Rate of Return Instrument Review

Response to AER's Draft Instrument and
Explanatory Statement

2 September 2022

Figure 2: Margin between 25-year re-setting bond and 5-year government bond

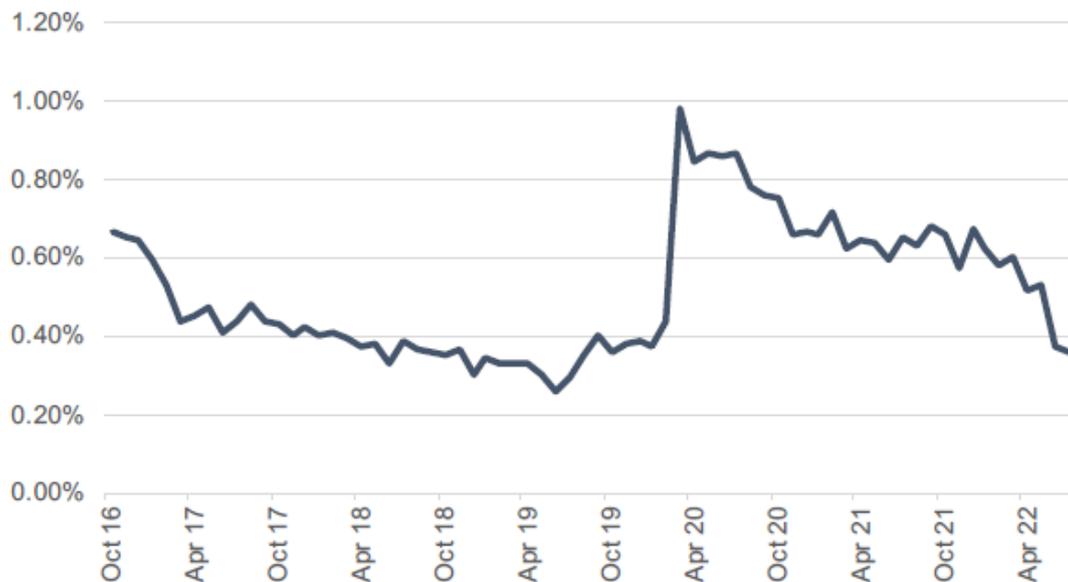
The QTC submission demonstrates how this differential can be quantified. QTC estimates the yield on a synthetic long-term bond where the coupon re-sets to the prevailing 5-year government bond yield every 5 years. The results are summarised in Figure 2 below.

Figure 2 shows, and QTC reports, that the margin that must be paid on the long-term re-setting bond, relative to a standard 5-year bond, averages 51 basis points. Over the same period, the average differential between the 10-year and 5-year government bond yield is 44 basis points.¹¹²

Figure 3: AER vs. calibrated DGM estimates of MRP

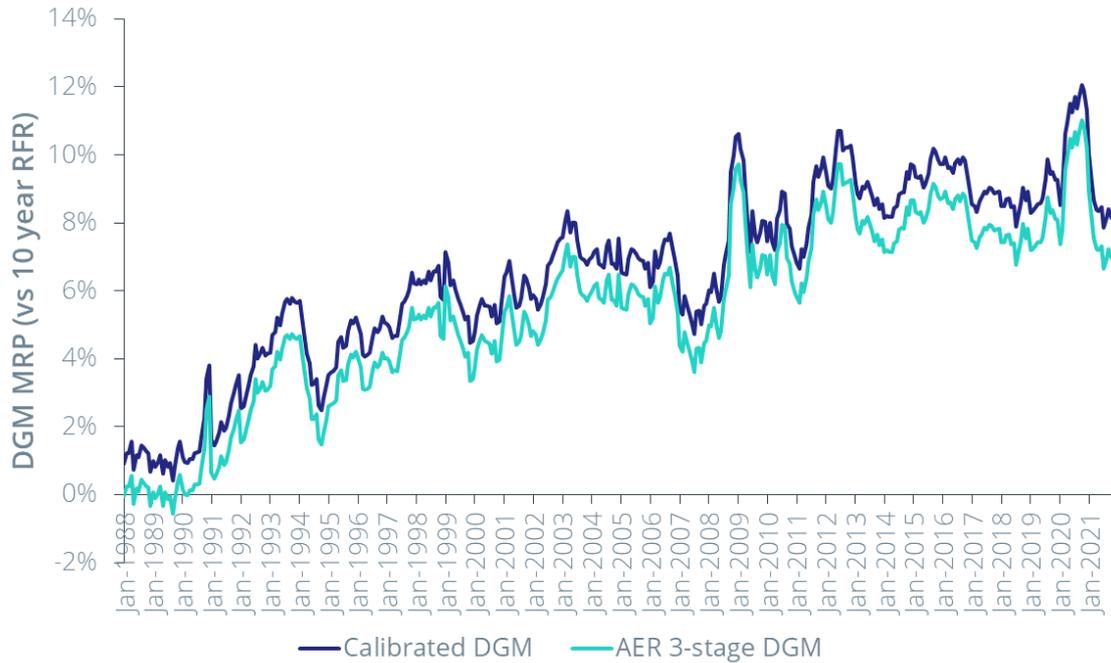
In relation to the volatility of estimates over the 1988-2021 period, we make two observations. The first is that the AER's preferred specification of the DGM generates estimates that are equally volatile. Figure 3 below plots the AER DGM estimates of the MRP alongside the calibrated DGM estimates. That figure shows that:

Figure 4: DGM vs. HER approaches to the allowed return on equity

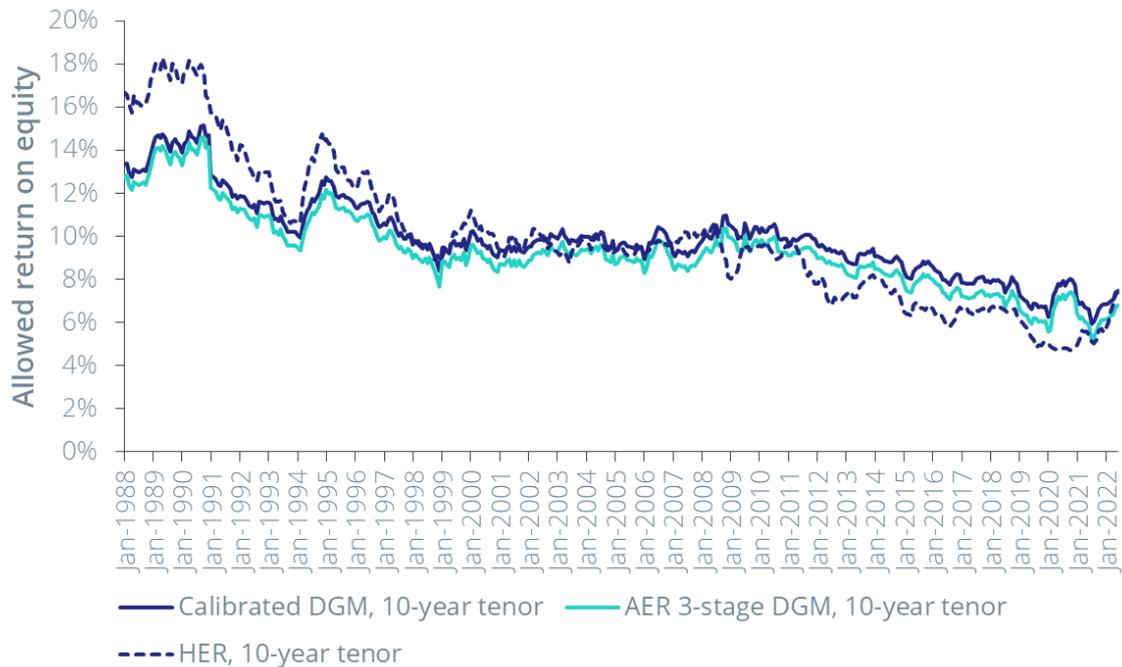
Our second observation is that what is most relevant to networks and consumers is not volatility in the MRP, but volatility in the allowed return on equity. Figure 4 below shows that both versions of the DGM (AER and calibrated) produce an allowed return on equity that is much more stable than the HER approach.

Relative to the DGM estimates, the HER approach produces materially higher allowed returns during periods of high interest rates and materially lower allowed returns during periods of low interest rates. The greater stability in the DGM estimates results in the implied MRP changing in a way that absorbs/offsets some of the volatility in risk-free rates.

Figure 5: Excess and real returns: 1988-2021

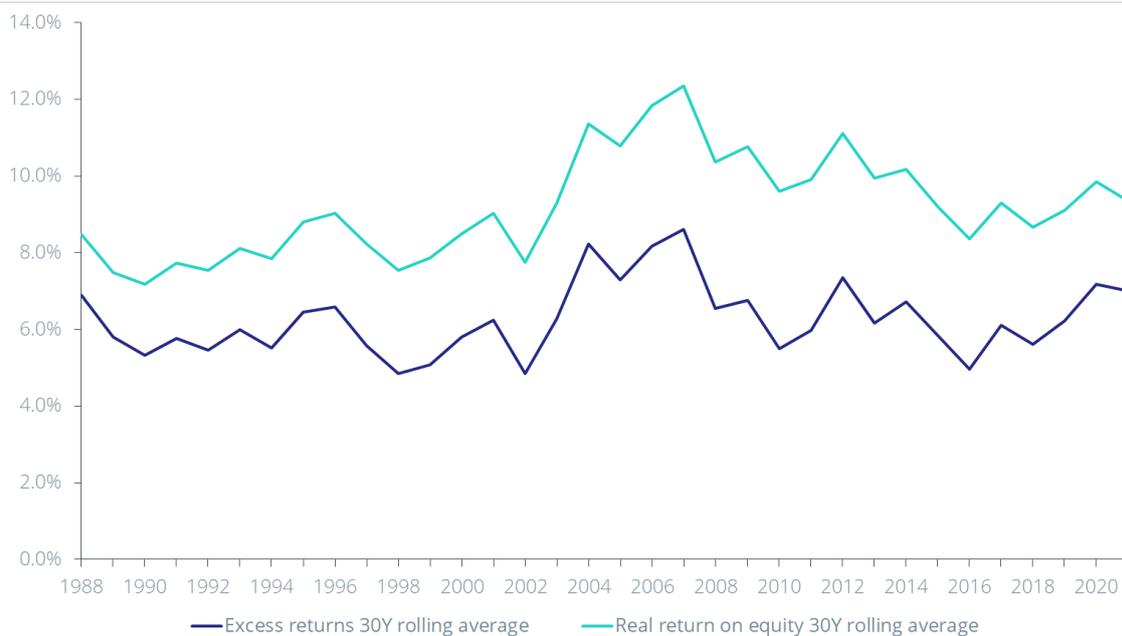
Finally, given that the AER proposes to apply primary weight to the historical period from 1988-2021, that is the relevant period for any tests of stability. The excess returns and real returns series – for the period that forms the basis of the AER’s allowance – are displayed in Figure 5 below.

Figure 5 shows that the pattern of excess returns and real returns is almost indistinguishable over the relevant period. It certainly does not support the conclusion that one approach should receive 100% weight and the other 0% weight on the basis of their relative stability.

Figure 6: International equity beta estimates and AER proposed beta

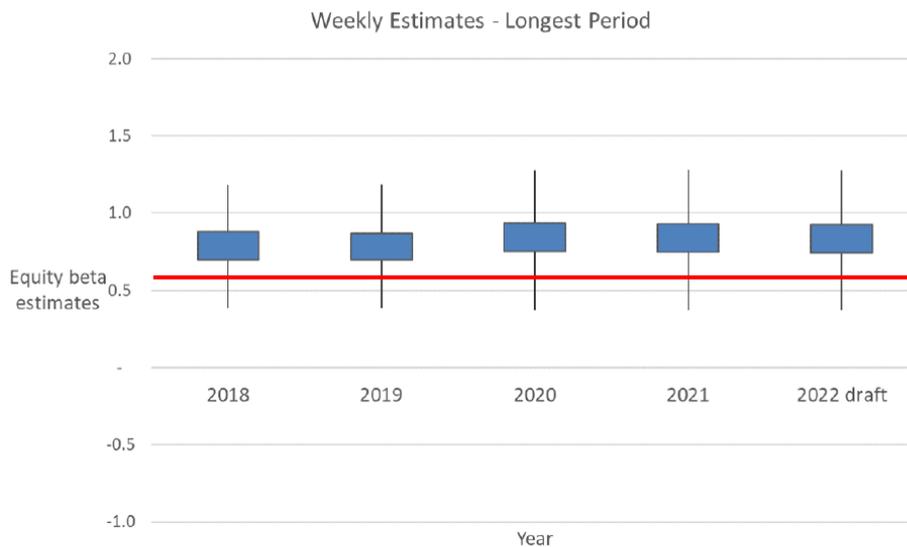
The AER reports equity beta estimates for a set of international comparator firms, as set out in Figure 6 below. That figure shows that the current international evidence supports an equity beta very materially higher than the AER's proposed allowance of 0.6 (marked in red on the figure).

Figure 7: Returns on high-beta and low-beta stocks

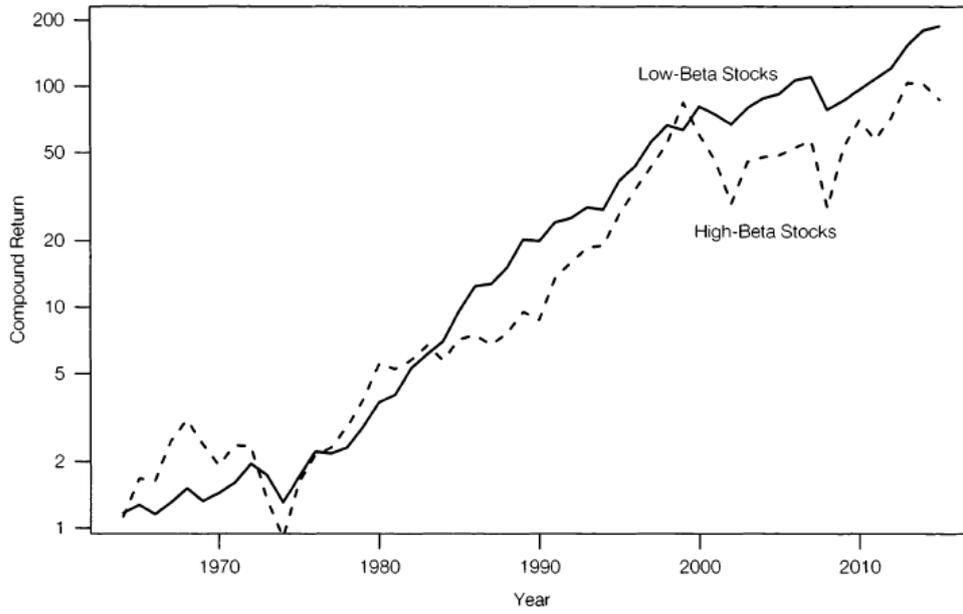
By way of example, Levi and Welch (2017) have noted that low-beta stocks have outperformed even high-beta stocks over the last 50 years, as summarised in Figure 7 below.

- » Investors would form their expectations about MRP according to what they observed, on average, over the last 30-50 years; but that
- » Investors would disregard the same data over the same historical period when forming their expectations about the returns on low-beta stocks relative to other stocks.

Figure 8: Comparison of allowed returns under 2018 RoRI and draft 2022 RoRI

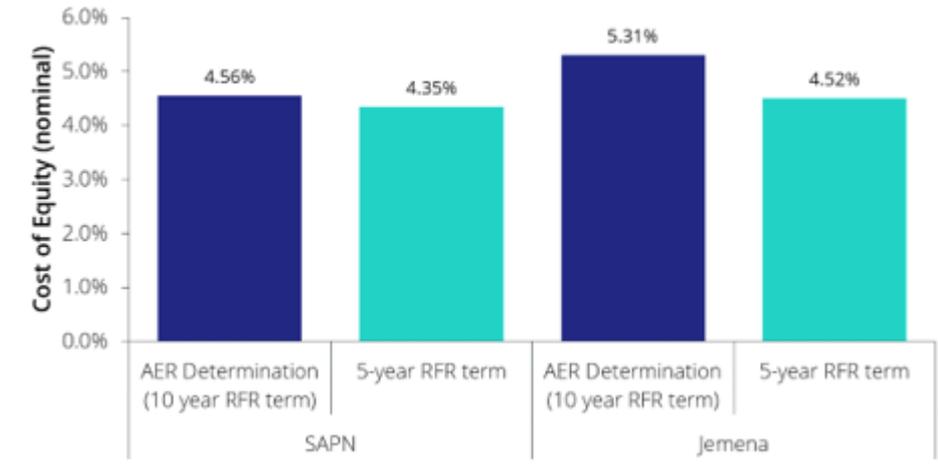
Remarkably, the proposed changes in the draft 2022 RoRI would result in *even lower* regulatory allowances in that same low-rates scenario. For example, Figure 8 below shows that the allowed return on equity for the 2020 SAPN and Jemena decisions would have been even lower under the approach proposed in the draft 2022 RoRI.

Figure 9: Comparison of allowed returns under 2018 RoRI and draft 2022 RoRI

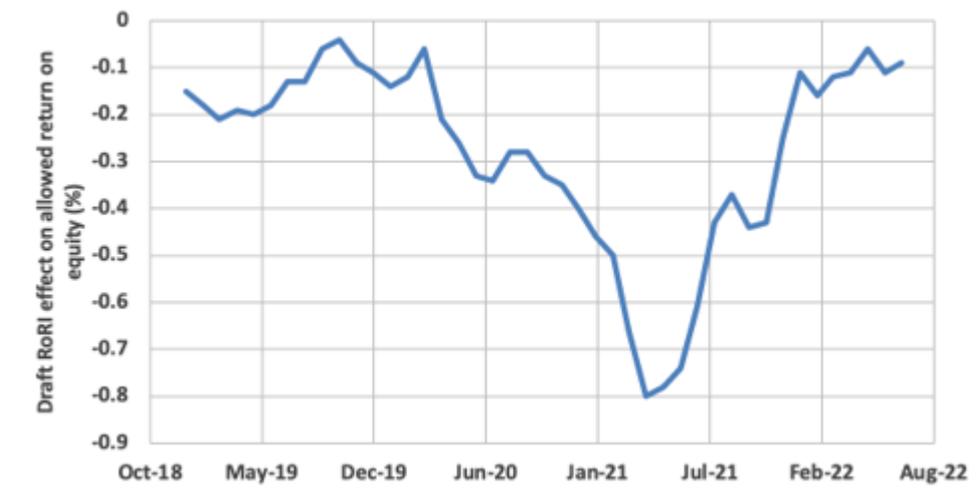
Figure 8 below shows that the allowed return on equity under the draft 2022 RoRI would have been up to 80 basis points lower than the corresponding allowance under the 2018 RoRI.
